RESOLUTION NO. 2191

A RESOLUTION OF THE CITY COUNCIL OF THE CITY OF KIRKLAND GRANTING APPROVAL, SUBJECT TO CERTAIN SPECIFIC CONDITIONS, OF THE PRELIMINARY PLAT OF LAKE VISTA TERRACE DIVISION #2, BEING FILE NO. SUB-73-19(H), DEPARTMENT OF COMMUNITY DEVELOPMENT

TRANSMITTAL REPORT

Report Prepared: May 29, 1973 File No.: SUB-73-19(H)  
Name: Hal Brandt Hearing Body: City Council  
Property Location: N.W. Section of 60th St. & 106th Avenue Hearing Date: June 4, 1973  
Subject: Preliminary Subdivision Application

LAKE VISTA TERRACE DIV. 2  
 PRELIMINARY PLAT  
 873

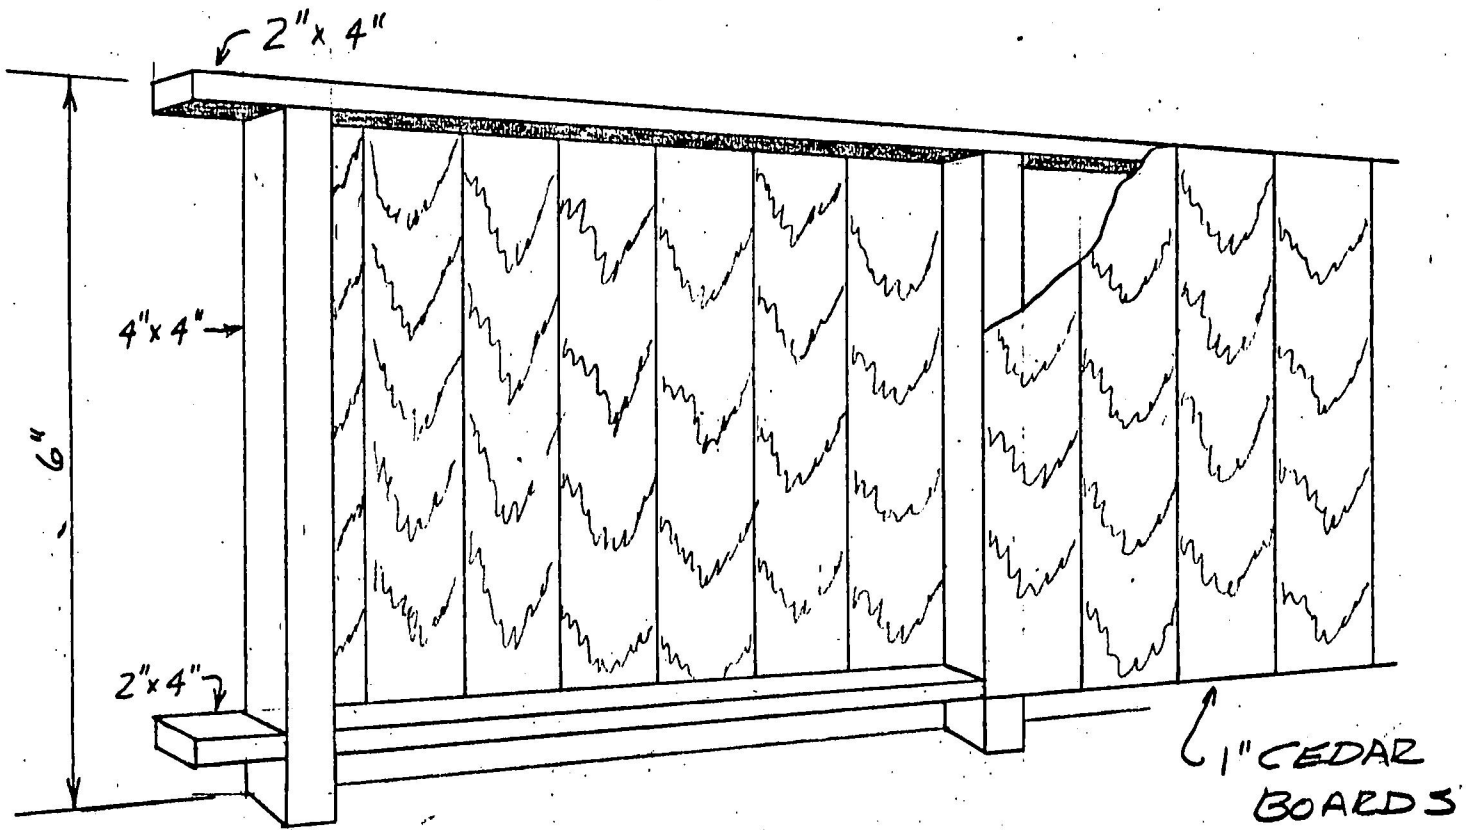
- a. Lots 26 through 29 be reconfigured by eliminating one lot in order to create one larger lot in which a walking trail could be located in the rear yard area. (This would reduce the total number of lots in the plat from 27 to 23.)
- b. That a walking and bicycle easement be located adjacent to Lots 10, 11, 23 and 24. This would then connect the two cul-de-sacs and 105th Ave. N.W. to the north. It was recommended that the developer's engineer and the Park Director meet to determine the proper width of these walking and bicycle trail easements.
- c. That the natural island, as shown in the cul-de-sac adjacent Lots 32 through 37, be retained.
- d. That a variance be granted to allow the 20 foot access for Lots 8 and 25 which are served by street 20 feet wide entries as shown.

25. No open space has been included in the preliminary plat proposal. Open space may be required pursuant to Section 2.5.9 of the Kirkland Subdivision Ordinance. As much as 3.5% open space can be required, which would amount to approximately 15,000 square feet for this preliminary plat.

26. Sidewalks have not been proposed on the interior streets of the subdivision. The Houghton Community Council has recommended approval of the preliminary plat without the requirement for sidewalks on the two interior cul-de-sacs.

28. No specific conditions were presented by the Houghton Community Council for the island in the cul-de-sac adjacent to Lots 32 through 37 and, specifically, whether or not this island would be in the public right-of-way for public maintenance or would be the responsibility of the residents in the plat.

2. The Planning Commission finds there is a necessity for provision of a minimum of 3.5% open space as required by Section 2.5.9 of the Kirkland Subdivision Ordinance. The Commission delegates to the Department of Community Development the authority to reach an equitable agreement with Mr. Brandt on the location and configuration of the required open space.

4. The Planning Commission finds that the area to be devoted to open space together with the cul-de-sac island abutting Lots 32 through 37 should be dedicated to the City of Kirkland with a specific provision on the face of the plat that all development and maintenance of these facilities shall be the responsibility of the owners of the lots within the plat.

A copy of the revised preliminary plat drawings, the revised drainage plan and the fencing detail as modified by this report are hereby attached to this report and approved subject to the conditions and stipulations herein contained.

LAKE VISTA TERRACE DIV. 2  
DRAINAGE PLAN

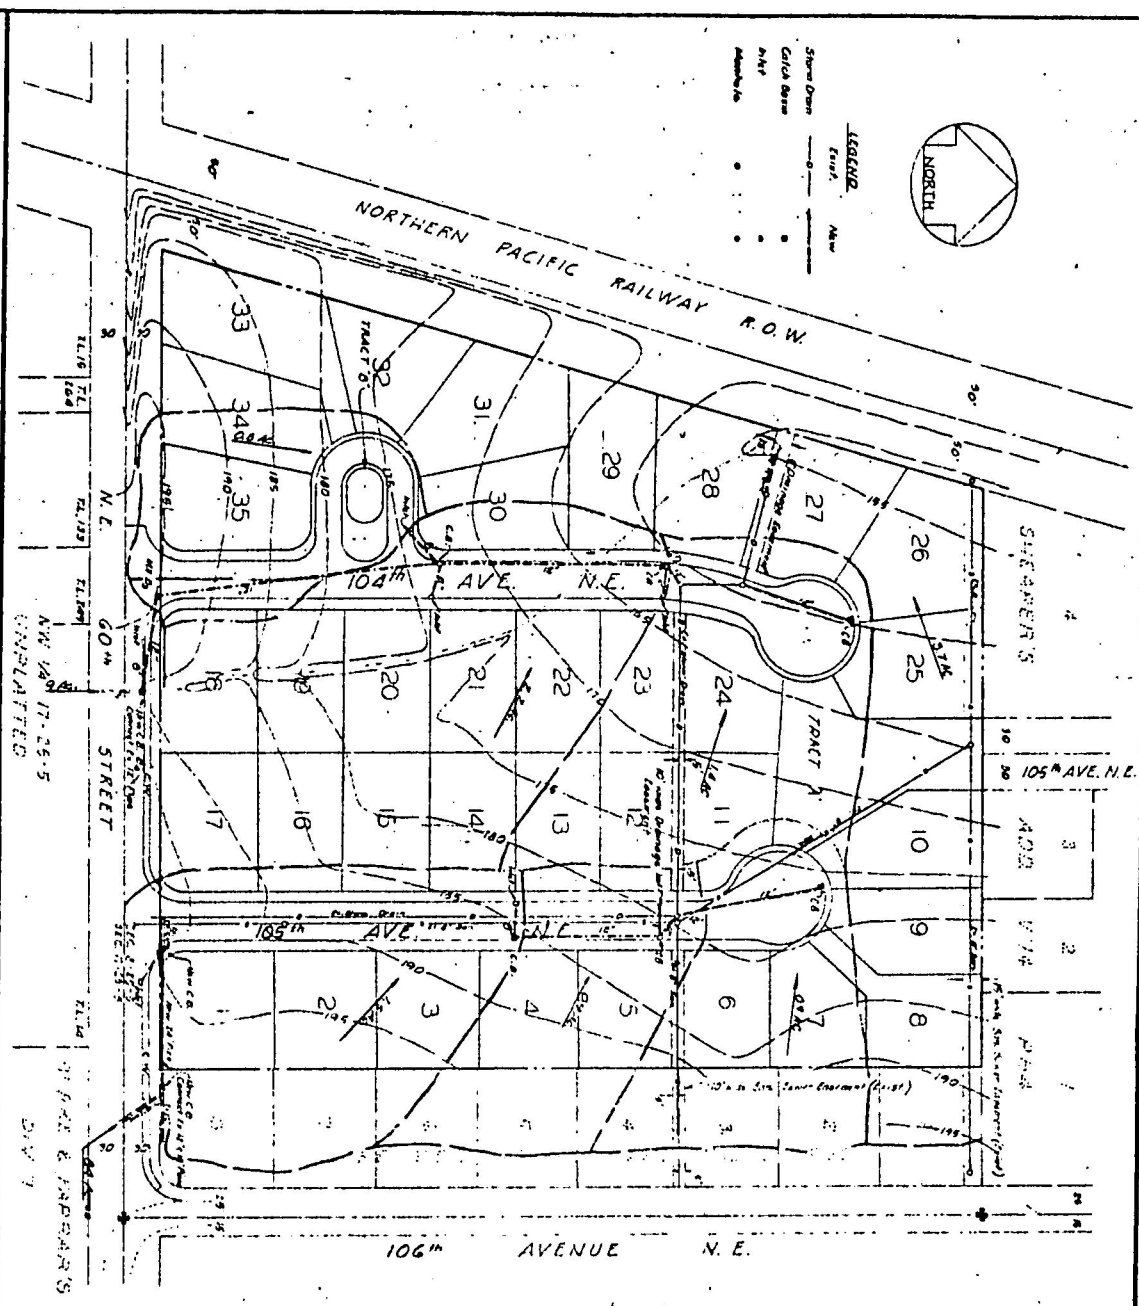
15. A former watercourse flowing to the southwesterly of the plot enters an existing storm drain pipe near the north-east corner of the property and encroaches the property laterally, leaving the property in a pipe beneath the adjacent right-of-way.

16. The drainage going through this property and responsible for a washout last winter on Lake Washington and approximately N.E. 63rd Street.
17. The proposed subdivision meets all requirements of the Zoning and Subdivision Ordinances with the exception of lots 8 and 15, which do not have the required amount of frontage on a right-of-way. This point has been addressed in an earlier finding and the Neughton Community Council has recommended approval of a variation for these two lots.

3. The Planning Commission finds that the storm drainage facilities for the plat shall be designed in accordance with requirements of the City of Kirkland, Department of Public Services.
